EEG-61

**REVIEW OF THE WIPP DRAFT APPLICATION TO
SHOW COMPLIANCE WITH EPA TRANSURANIC
WASTE DISPOSAL STANDARDS**

Environmental Evaluation Group
New Mexico

March 1996

Figure 1. Oil and natural gas resource categories. After Broadhead et al., 1995.²⁻¹⁷

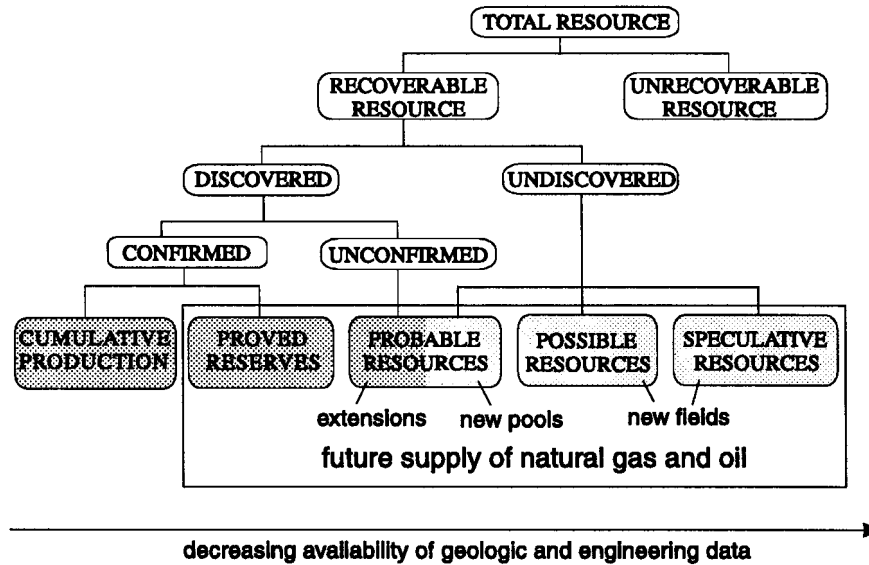
The definitions for the terms *proven reserves*, *probable reserves* and *possible reserves* are incorrect. The correct terms are proved reserves, probable resources, and possible resources (See Figure 1).

The DCCA definitions are given without reference and are inconsistent with the definitions used in Broadhead et al.²⁻¹⁷, as discussed below.

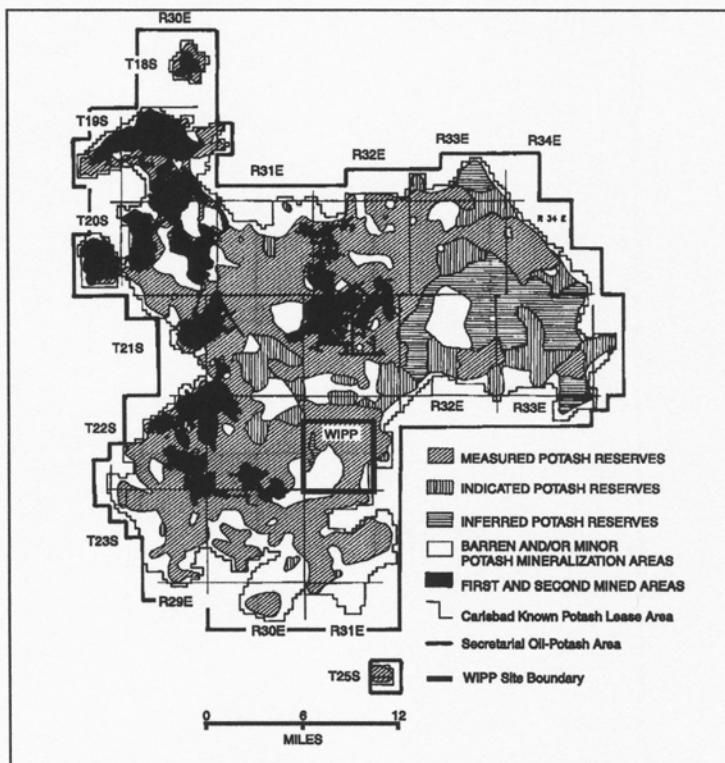
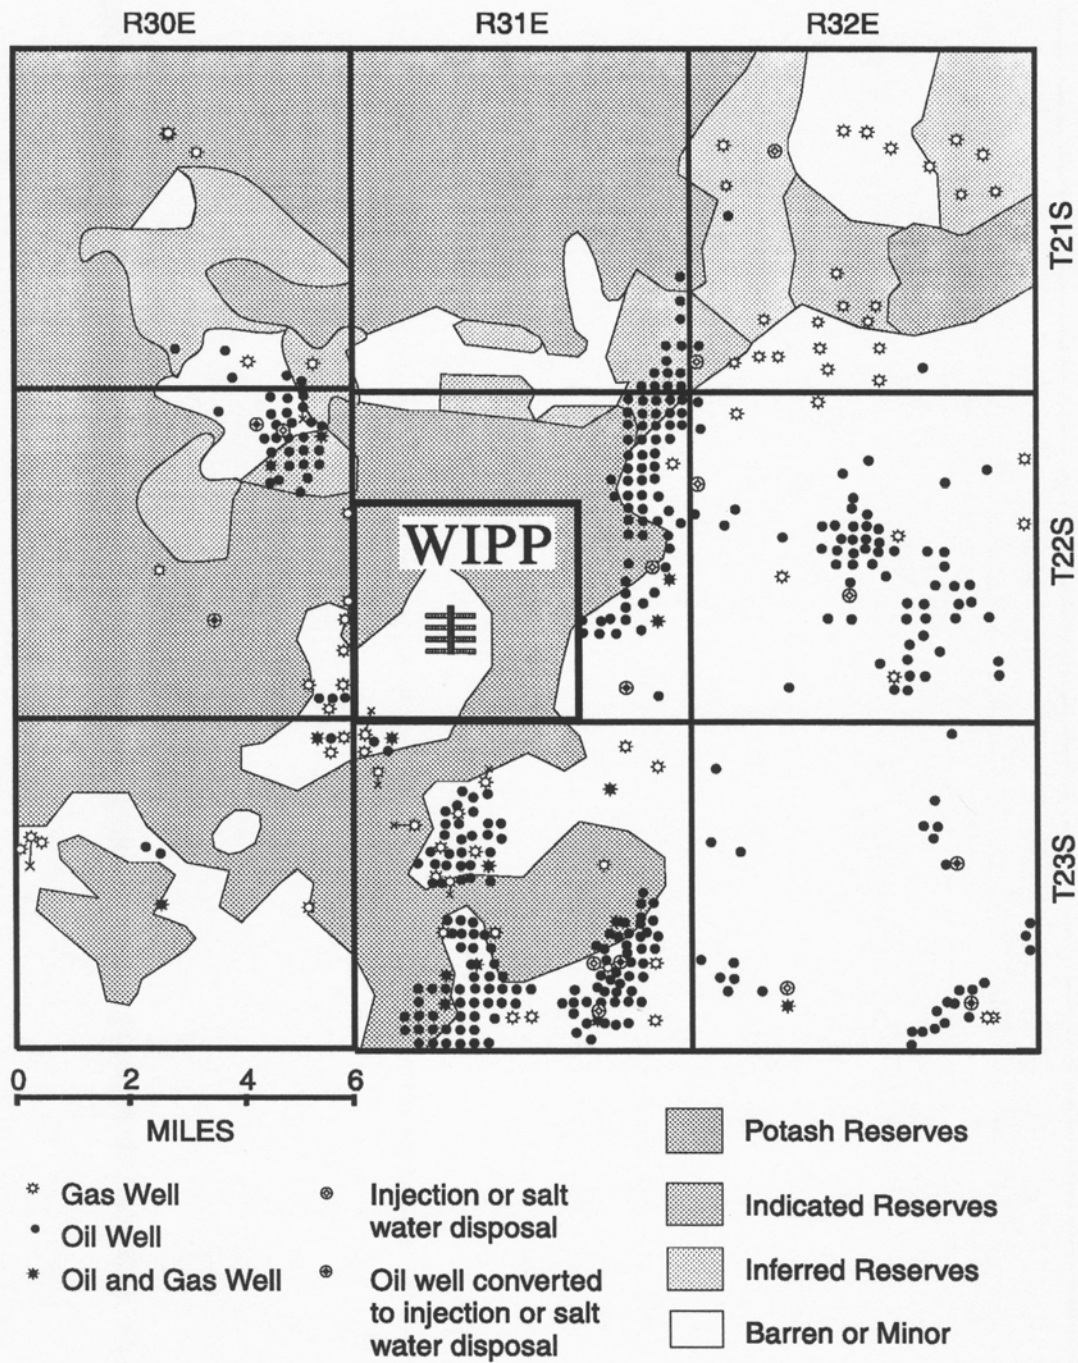
Page 2-117, line 34 and Table 2-5.

It appears that the quantities of potash summarized by this table are incorrect and do not reflect the higher quantities considered by the BLM to be reserves as a matter of official policy. The discussion would benefit from maps of the potash resources such as that prepared by Griswold and Broadhead et al.²⁻¹⁷, and those prepared by Silva for the June 13, 1995, EEG Workshop on waterflooding as shown in Figures 2 and 3.

Figure 4. Oil, gas, and injection wells in nine-township project study area. Adapted from Broadhead et al.²⁻¹⁷ by Matthew Silva (EEG).

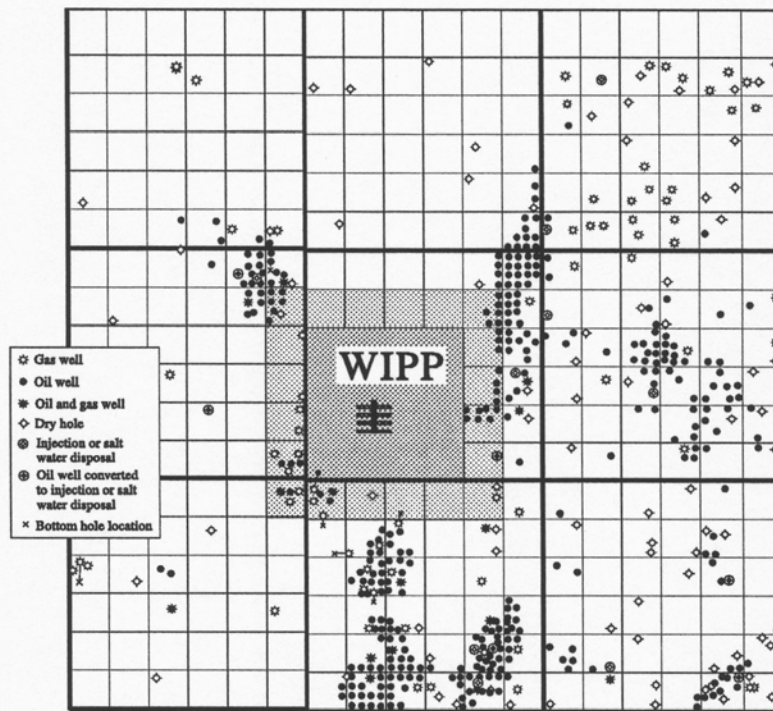
The section on hydrocarbon resources would benefit from a presentation of a map of current well locations and a map of existing oil and gas wells and applications for permit to drill as indicative of the interest of the oil and gas industry (Figures 4 and 5). The 1995 summary of previous evaluations by Broadhead et al.²⁻¹⁷ is mentioned in this section but the 1994 summary and analysis by Silva²⁻¹⁹ is not mentioned. Proper citation procedure dictates citing Silva²⁻¹⁹. It would also be worthwhile to provide a map of proven and probable reserves for the various formations such as those contained in Broadhead et al.²⁻¹⁷.

Figure 6. Estimates of WIPP RH-TRU Inventory from 1980 to 1995.

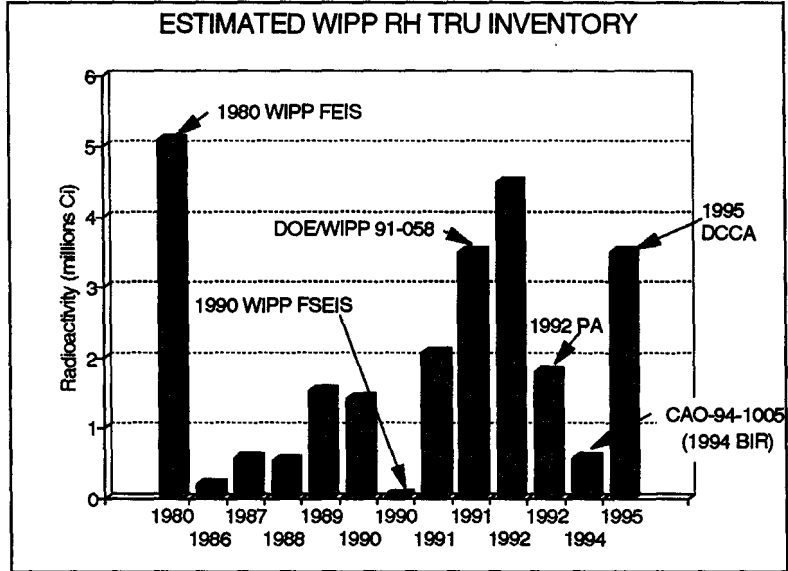
The DCCA suggests that the amount of RH-TRU is a small percentage of the WIPP TRU inventory. While this is true by volume, the RH-TRU waste is 37% of the total radioactive inventory according to the B.I.R. (Vol. III, page 4-11), and 33% of the total according to Volume I, page 4-15.

The inventory shown in Table 4-1 (page 4-4) does not agree with the inventory shown in Table 4-1 (page 4-5) of the Baseline Inventory Report published in Volume III, the supporting appendix (BIR). The RH-TRU projected inventory has varied widely over the years, as shown at the right⁴¹ (Figure 6). DOE should make an effort to explain why the latest values are correct. Rev. 1 of the BIR increased the RH-TRU inventory by a factor of 3 to 4 and Rev. 2, December 1995 (received 2/9/96) increases the RH-TRU inventory by a factor of 5.6 over Rev. 1 to 27.000 m³, considerably larger than the existing design capacity of 7080 m³ for the RH-TRU.

Figure 7. Comparison of Cranwell and DCCA Elimination Criteria.

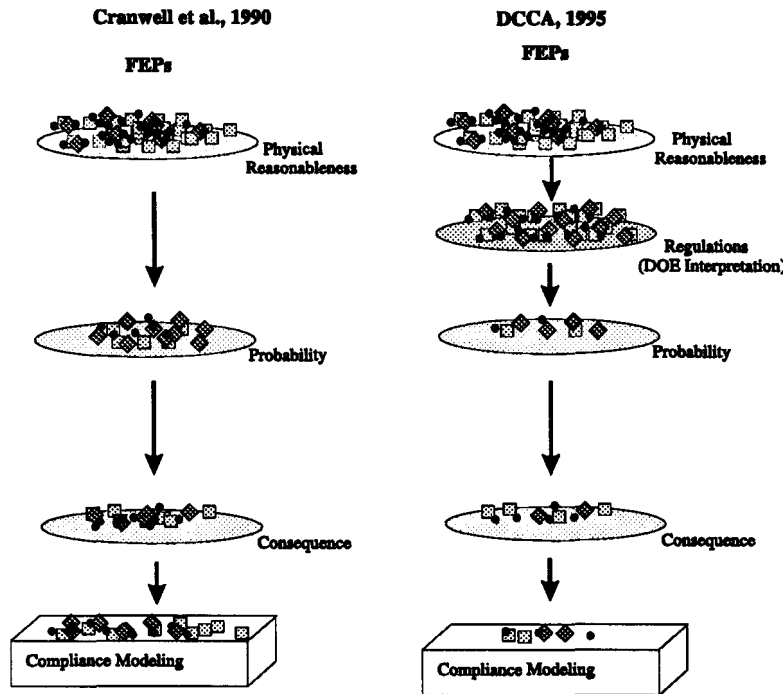
Interpretation) as shown in the figure below. Further, the procedure is such that the DOE determines which scenarios can be eliminated based on the DOE interpretation of the EPA regulations.

Delete as a criteria for elimination of FEPs the new category, "Regulation or, more broadly, *scope and purpose of the assessment...*" The category is entirely subjective as applied and ignores valid technical considerations.

Figure 8. Natural Resources around WIPP site.

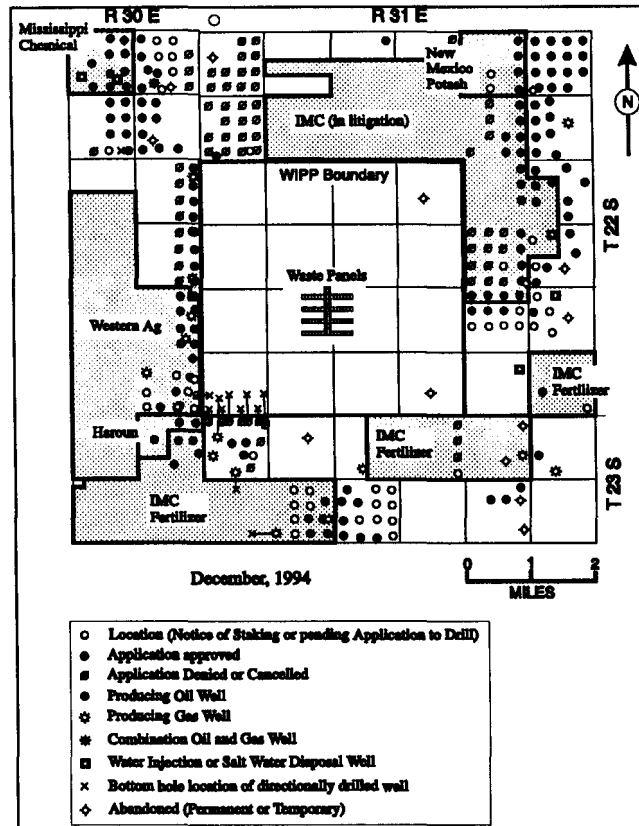
The WIPP is undeniably located in a resource rich area as shown in the Figure 8.

Figure 2
(From Reference 9)

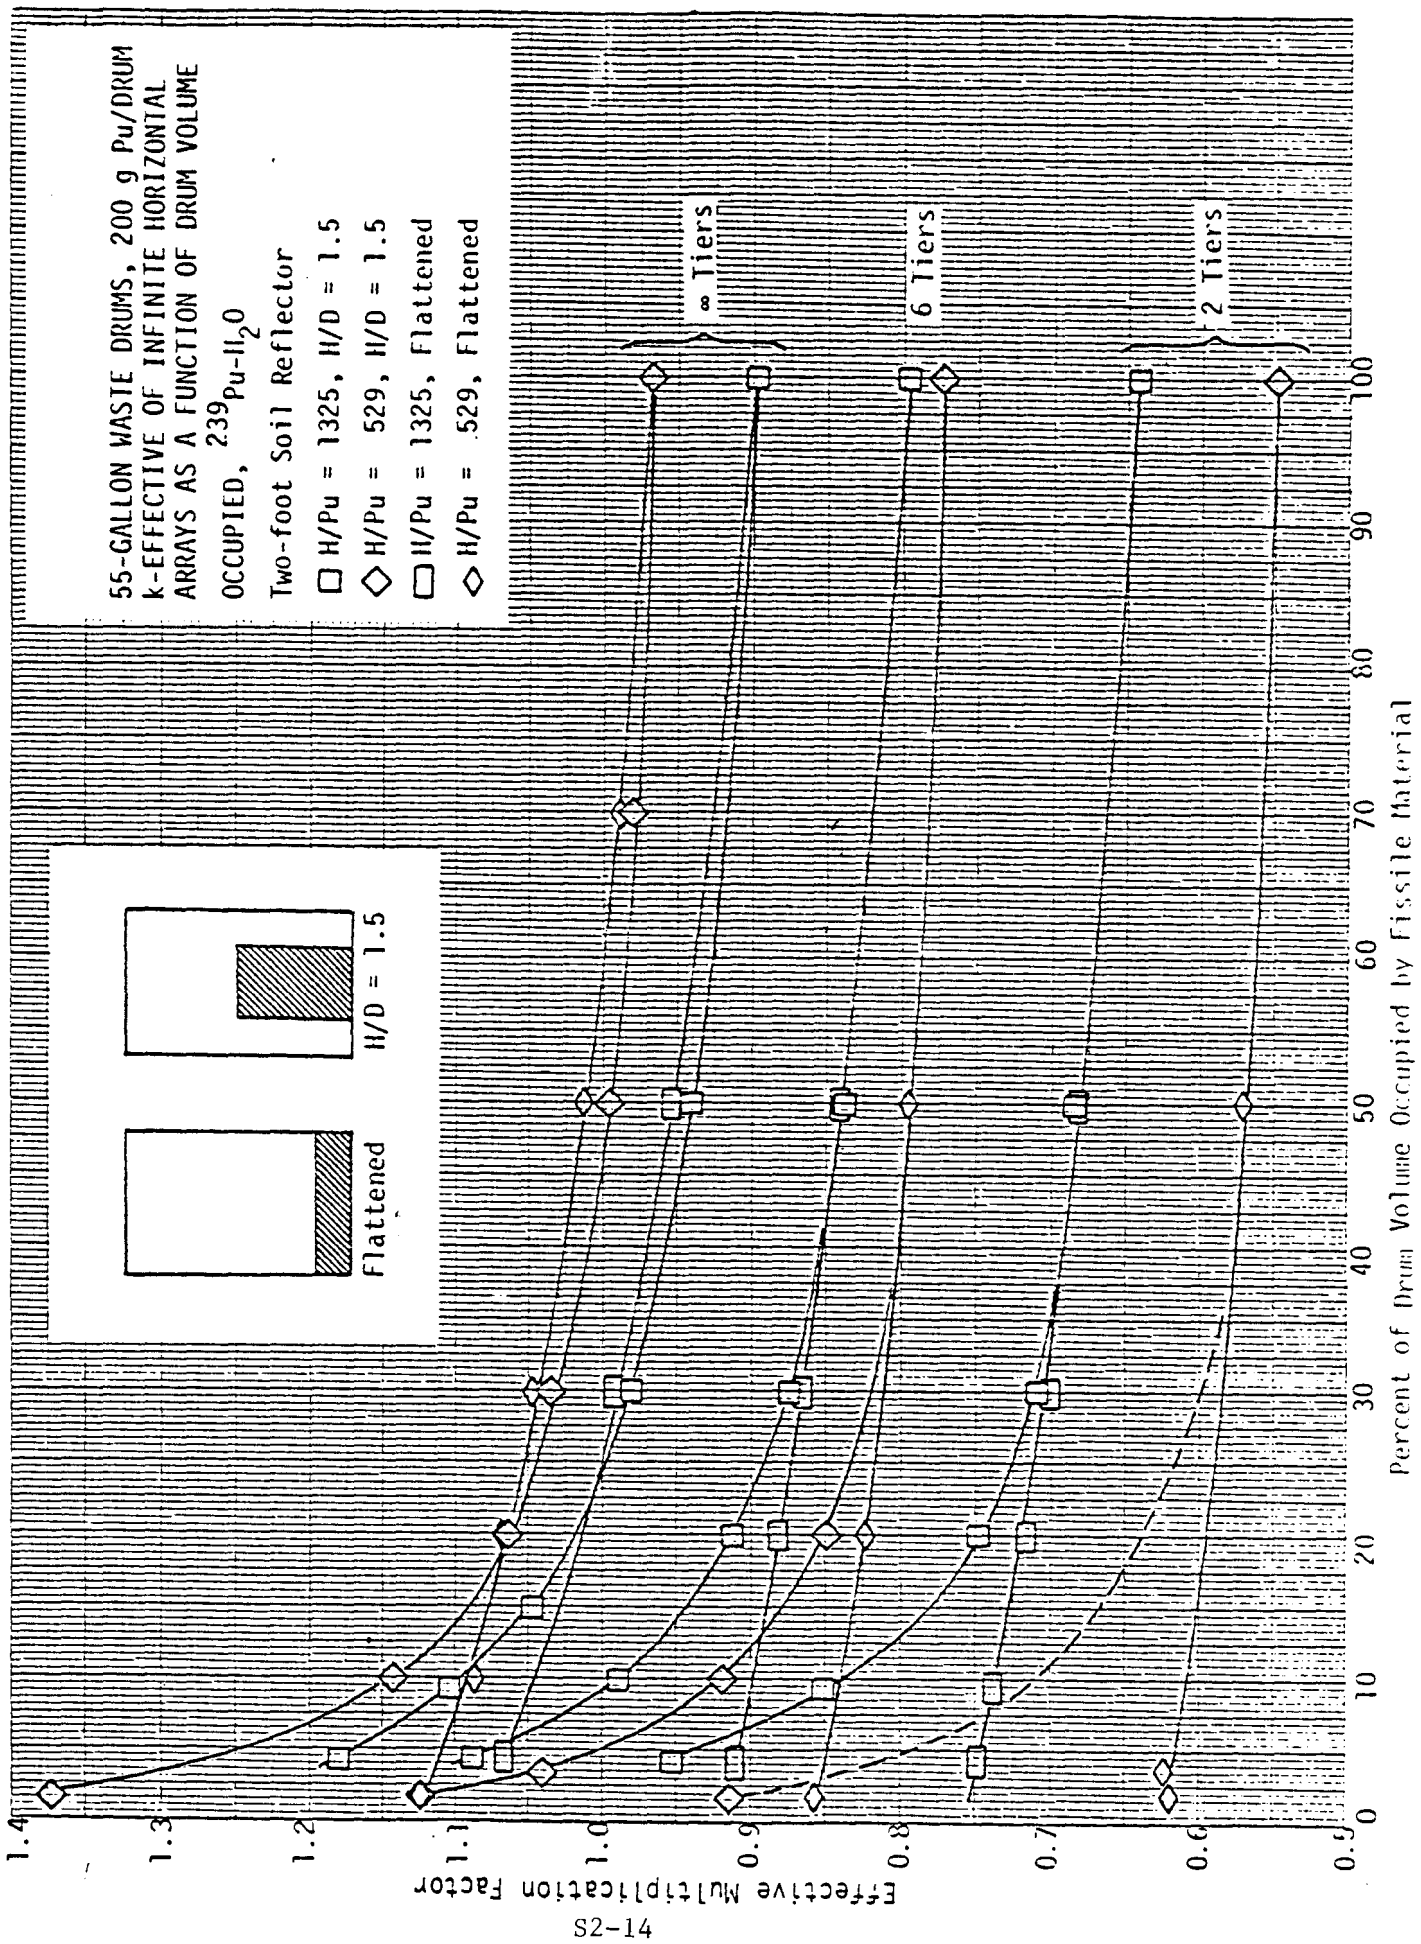
No attempt will be made to summarize all of the results here (approximately 200 separate calculations were performed). However, the most significant contribution of this work is the clear demonstration of the important effect that shape and density of the fissile material in the drum have on the results. The results demonstrate that modeling the plutonium-moderator mixture as uniformly distributed throughout the drum is not a conservative assumption. This is most clearly demonstrated in Figure 2, reproduced from Reference 9.

Figure 2 contains 3 sets of curves--corresponding to three heights of the array--an infinite number of tiers, 6 tiers, and 2 tiers. Each set of curves is displayed for two hydrogen to plutonium ratios, 1325 and 529. (Note that for the finite number of tiers, the higher H/Pu leads to higher k_{eff} values; this direction is reversed for the infinite number of tiers.) For any one of the curves, the point at the right (100% of drum volume occupied by fissile material) corresponds to the $\text{Pu}^{239} - \text{H}_2\text{O}$ mixture smeared uniformly over the entire drum volume. As we move to the left, the mixture is compressed, either by flattening (denoted by \square and \diamond) or by "scrunching" into a cylinder with $H/D = 1.5$ (denoted by \square and \diamond). The mode of volume reduction does not appear to affect the results down to roughly 35-40% reduction in volume for the 2 and 6 tier calculations. At this point the $H/D = 1.5$ results depart significantly from the flattening results.*
